TENNESSEE VALLEY AUTHORITY

Enclosed is revision 17 to the Watts Bar Nuclear Plant ASME Section XI Preservice Inspection Program Technical Instruction TI-50A. Included in the revision is the revised section of request for relief ISI-4 and ISI-14. The changes are listed below. Listed below are changes and a status of the requests for relief that has been identified for the preservice inspection program. We do not anticipate adding any additional request for relief to the program.

WATTS BAR NUCLEAR PLANT

PRESERVICE INSPECTION
PROGRAM

CH-M-2660-B R 3

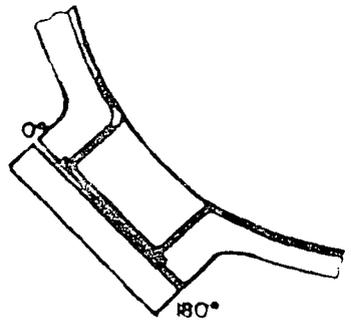
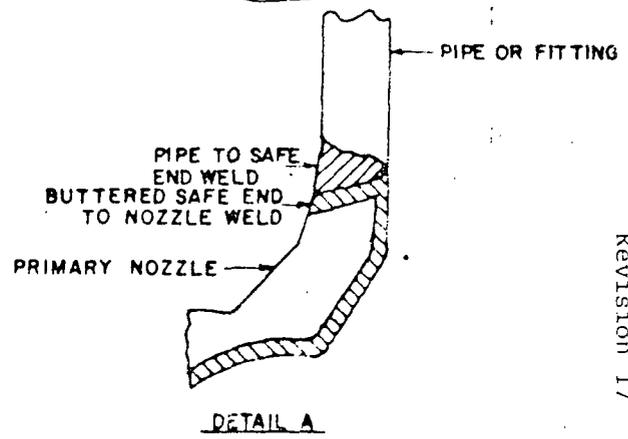
3	3-6-85	ADD NOTES AND REFERENCES TO THE NOTES	CKD	APP
2	8-6-84	ADD DETAIL A	CKD	APP
1	7-13-84	CORRECT BOLT NUMBER SEQUENCE AND DELETED NOTE	CKD	APP
NO	DATE	REVISIONS	CKD/APP

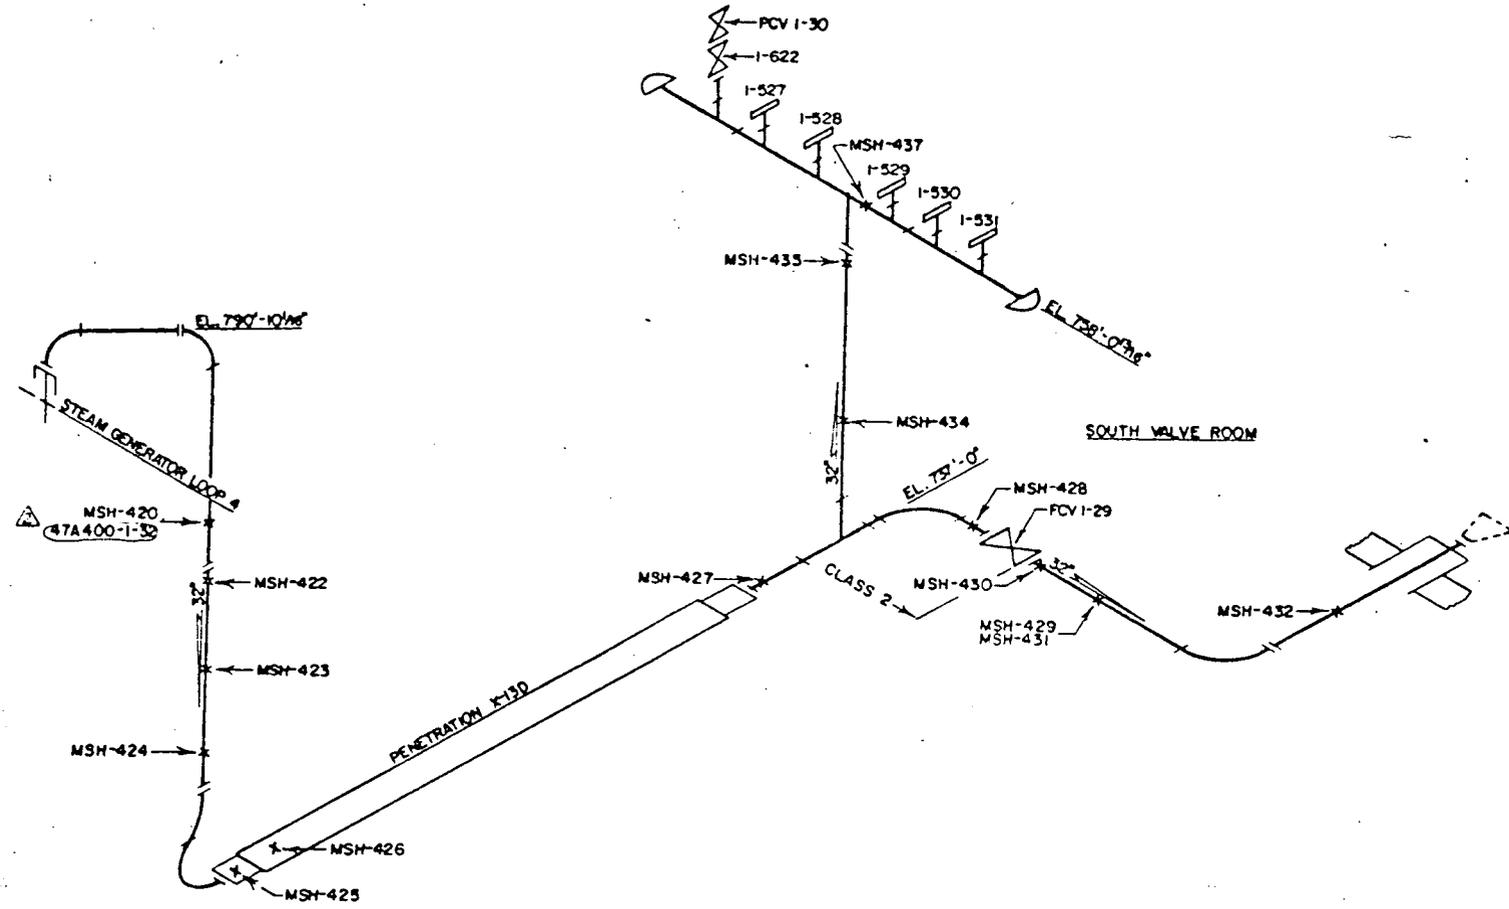
NO.	DATE	REVISIONS	CK'D BY
2	5-22-85	CORRECTED HANGER NO. JAA	QJA/MS
1	1-20-84	CORRECT REFERENCE DRAWING #17	JCC/MS
REVISIONS			CK'D BY
TENNESSEE VALLEY AUTHORITY			
DIVISION OF NUCLEAR POWER			
WATTS BAR NUCLEAR PLANT			
UNIT #1			
MAINSTEAM SYSTEM			
HANGER LOCATIONS			
DATE	BY	APP'D	NO.
8-24-81	MS	JAB	SI-0011-C
